Title of Change:	AR1337 Die Datasheet Update.
Effective date:	22 Apr 2020
Contact information:	Contact your local ON Semiconductor Sales Office or Sonya.Yip@onsemi.com
Type of notification:	This Product Bulletin is for notification purposes only. ON Semiconductor will proceed with implementation of this change upon publication of this Product Bulletin.
Change Category:	Documentation Change
Change Sub-Category(s):	Datasheet/Product Doc change

The AR1337 Die Datasheet has been converted to official ON Semiconductor format and updated. These changes do not affect form, fit, or function of the product.

Figure 3: Die Orientation in Reconstructed Wafer, 150 μm thickness

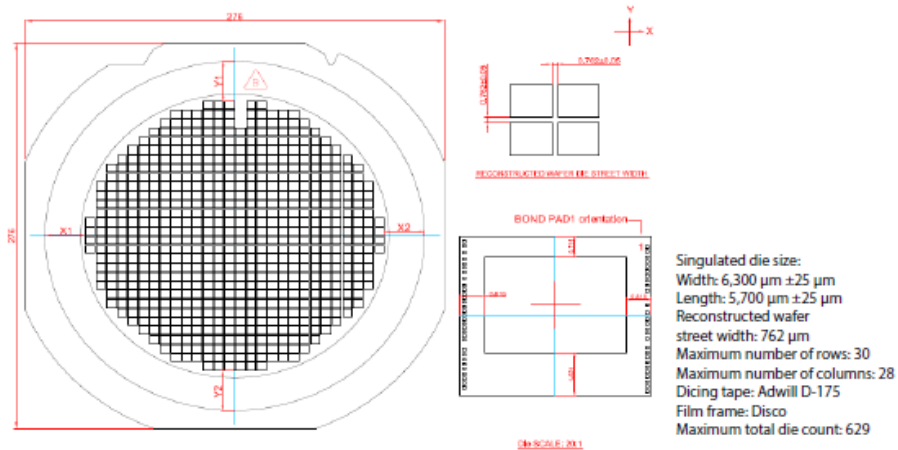
3. Removed "Figure 3. Die Orientation in Reconstructed Wafer, 150 μm thickness"
